RESOLUTION ON REQUEST FROM QUIK TRIP CORPORATION TO AMEND THE PLANDSM: CREATING OUR TOMORROW PLAN FUTURE LAND USE DESIGNATION (1522 CAPITOL AVENUE)

Communication from the City Plan and Zoning Commission advising that at their meeting held September 15, 2016, the following actions were taken regarding requests from Quik Trip Corporation (owner) represented by Michael Talcott (officer) on property located at 1501 & 1515 East Grand Avenue and 1522 Capitol Avenue.

STAFF REPORT TO THE PLANNING COMMISSION

SITE PLANS FOR QUIKTRIP STORE #0535 1501 EAST GRAND AVENUE CITY OF DES MOINES, COUNTY OF POLK, STATE OF IOWA

SHEET TITLE:
SITE PLAN

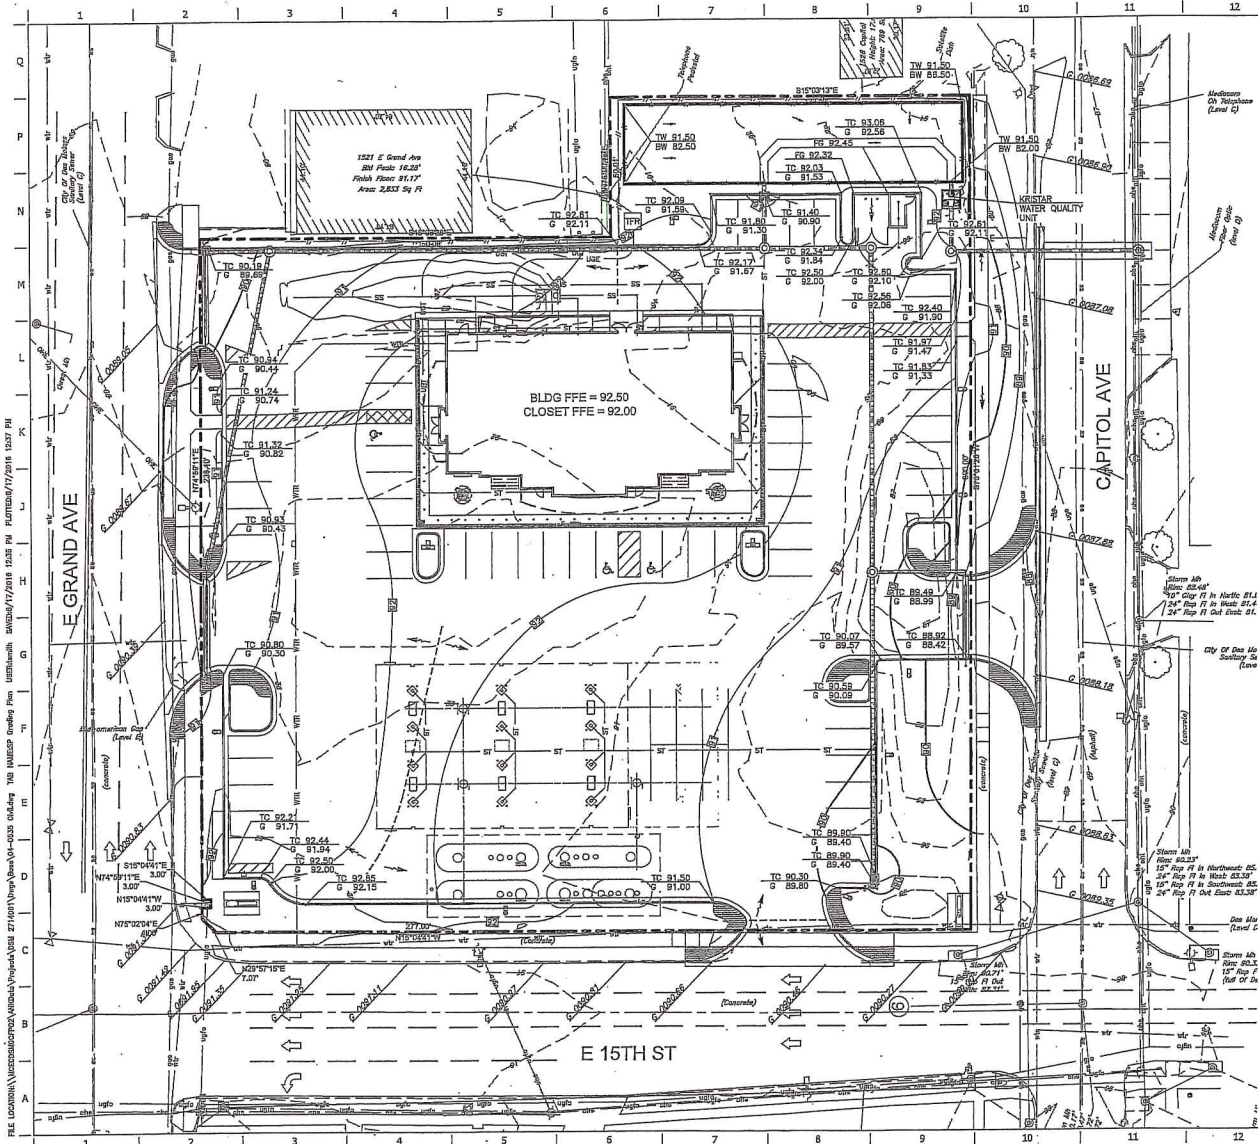
The applicant is proposing to redevelop the site with a new convenience store building and site improvements. The building would be located slightly to the east of the center of the site. It would be separated from the adjoining Rights-Of-Way by surface parking. The fuel pump island would be located to the west of the building along East 15th Street. The submitted Site Plan shows two driveways to East Grand Avenue, one driveway to East 15th Street and one driveway to Capitol Avenue. The Site Plan proposed to remove the existing access drive that provides ingress/egress from the west end of the alley to Capitol Avenue. The portion of the alley that used to extend through the site to East 15th Street was previously vacated and incorporated into the Quik Trip site. The alley is shown as a dead end at the east perimeter of the site, closed off with bollards.

The proposed layout consists of a standard, auto-oriented design. It does not support the existing pedestrian-oriented character of the East Grand Avenue corridor, nor does it comply with the goals of the City's Comprehensive Plan as listed above. Staff understands that achieving a mixed-use project at this site that includes a convenience store with fuel sales is not practical. However, the site should still be configured in a way that the building is located along East Grand Avenue, which would better fit the

The applicant is proposing to redevelop the site with a new convenience store building and site improvements. The building would be located on the eastern half of the site. It would be separated from the adjoining rights-of-way by parking. The fuel pump island would be located to the west of the building along East 15th Street. The submitted Site Plan shows two driveways to East Grand Avenue, one driveway to East 15th Street and one driveway to Capitol Avenue. The Site Plan includes removing the existing access drive that provides segregated egress from the west end of the alley to Capitol Avenue. The portion of the alley that used to extend through the site to East 15th Street was previously vacated and incorporated in the Quik Trip site. The submitted alley is shown as a dead end at the east perimeter of the site.

The proposed layout consists of a standard, auto-oriented design. It does not support the existing pedestrian-oriented character of the East Grand Avenue corridor, nor does it comply with the goals of the City's Comprehensive Plan as listed above. Staff understands that achieving a mixed-use project at this site that includes a convenience store with fuel sales is not practical. However, the site should be configured in a way that the building is located along East Grand Avenue to address the pedestrian-oriented corridor, which would better fit the existing character, support greater pedestrian connectivity, and address the goals of the PlanDSM Creating Our Tomorrow. Staff has presented this option to the applicant.

Perimeter lot plantings are required within the minimum 10-foot paving setback along all street side property lines of parking lots. Currently the setbacks are shown at 5.5 feet along some portions of Capitol Avenue and 7.93 feet along portions of East Grand Avenue and do not comply. All perimeter lot setbacks shall have a minimum 10-foot setback based on the amount of paving.

The interior parking lot minimum plantings require one (1) overstory deciduous tree and three (3) shrubs for every 20 parking spaces provided. They shall be within planter beds of no less than nine (9) by seventeen (17) or 153 square feet. The plans identify the islands with trees but no shrubs have been provided.

5. **Parking:** A minimum of 20 off-street parking spaces are required for the proposed 5,773-square foot building (1 per 300 square feet). The applicant is proposing 62 parking spaces. The PlanDSM seeks to minimize off-street parking area. In this instance the submitted plan provided over three times the required minimum. Based on this staff believes that reducing the number of parking spaces to revise the building location could be accomplished without compromising necessary parking.

6. **Drainage/Grading:** The submitted Site Plan indicates storm water management being handled by a surface detention basin at the eastern end of the site. This may need to be redesigned depending on the solution provided for egress of the east/west alley.

1. The public alley within the Property shall not be truncated and shall be connected to Capitol Avenue.
2. The applicant shall work with City staff to create an urban edge for the north streetscape (Grand Avenue frontage), to the approval of the Planning Administrator. (ZON2016-00100)

1. The public alley within the Property shall not be truncated and shall be connected to Capitol Avenue.
2. The applicant shall work with City staff to create an urban edge for the north streetscape (Grand Avenue frontage), to the approval of the Planning Administrator. (10-2017-7.19)

LANDSCAPE PLAN

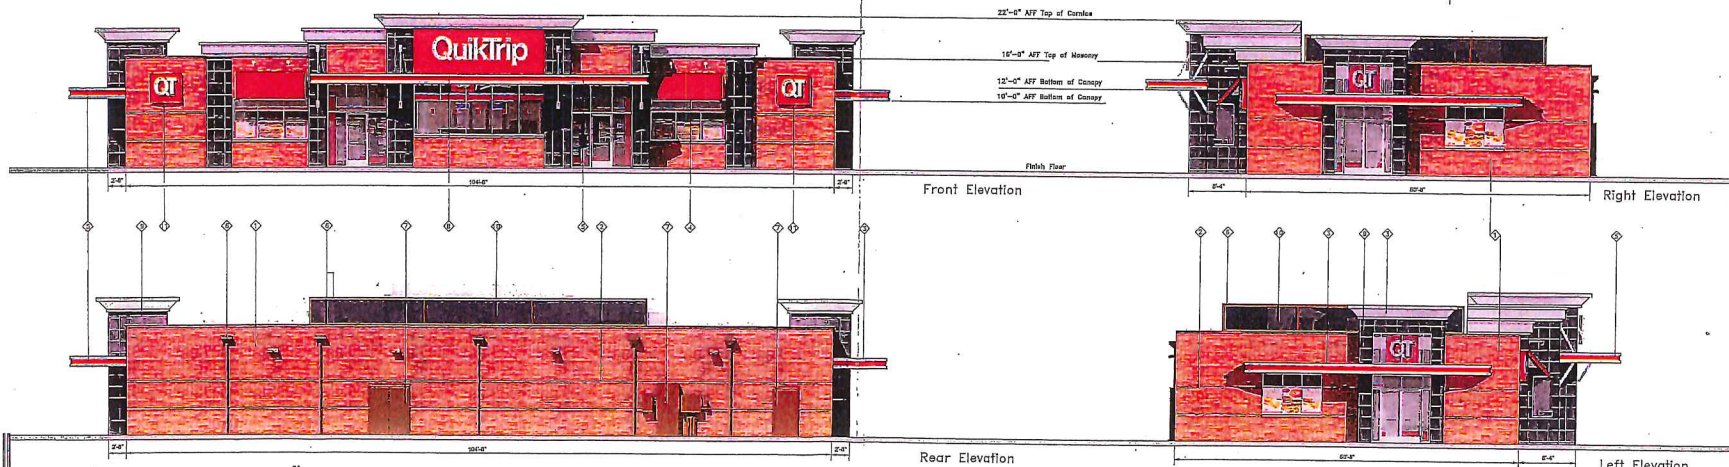
The submitted site plan does not comply with the City's Landscaping Standards. Minimum open space should be 20% of the site or 1,000 square feet per vehicle fueling location, whichever is greater. The greater requirement in this case is the 20% provision or 15,424 square feet. The Site Plan proposes 13,807 square feet (17.9%) of open space. The pavement and/or building footprint would need to be reduced to meet this requirement. Additional open space could also be obtained by expanding interior planting islands throughout the site.

The Site Plan needs to be revised to provide a 10-foot bufferyard where adjacent to the residential use to the east. Minimum planting requirements for bufferyards are two (2) overstory tree and six (6) evergreen trees per 100 lineal feet of property line, in addition to the 6-foot screen. There is approximately 130 lineal feet of required bufferyard along the east property line demanding this requirement. Should the alley egress be provided in this location, the bufferyard should be between the alley and the existing residences.

To meet the intent of PlanDSM by tying into the existing pedestrian corridor, staff recommends providing parkway planting requirements. This would call for one overstory tree per 30 lineal feet within the Right-Of-Way in 5-foot by 15-foot planters, 1 foot back of curb within the sidewalk along East Grand Avenue, with a 6-foot dedicated walk width.

To meet the design guideline for enhancing the overall appearance, staff recommends providing a minimum 42-inch tall decorative black metal fence around the perimeter of the site along East Grand Avenue and East 15th Street. This would not have to be continuous but could be broken up with other landscape features. Shrub landscaping that is indicated on the landscape plan is located on the outside, or street facing side of the fence.

Store # 0535 Double Stack 6 Canopy Elevations
 Serial # 04-0535-GD06
 Scale: 1/8" = 1'-0"
 Issue Date: 05.10.16

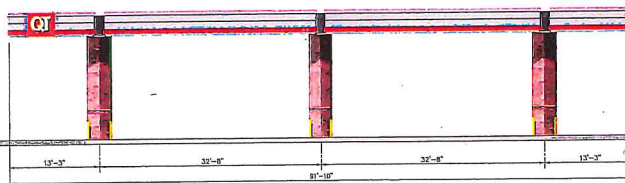
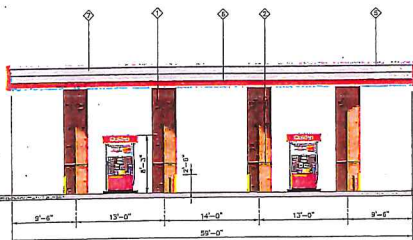
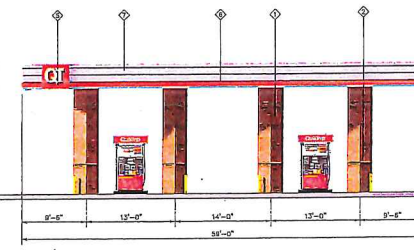
The three primary facades of the proposed building would be sided with brick and porcelain tile and would have aluminum cornices and entrance canopies. The rear façade would be sided with brick with no other detail. Staff recommends that porcelain elements be provided on the rear façade along with cornice design to match the other three facades. This is based on the east side of the building being within public view of East Grand Avenue.

The proposed building design includes wall plane variation and parapet wall height on the three street facing facades.

The proposed building design includes wall plane variation, material variety and varying parapet wall heights on the three street facing facades.
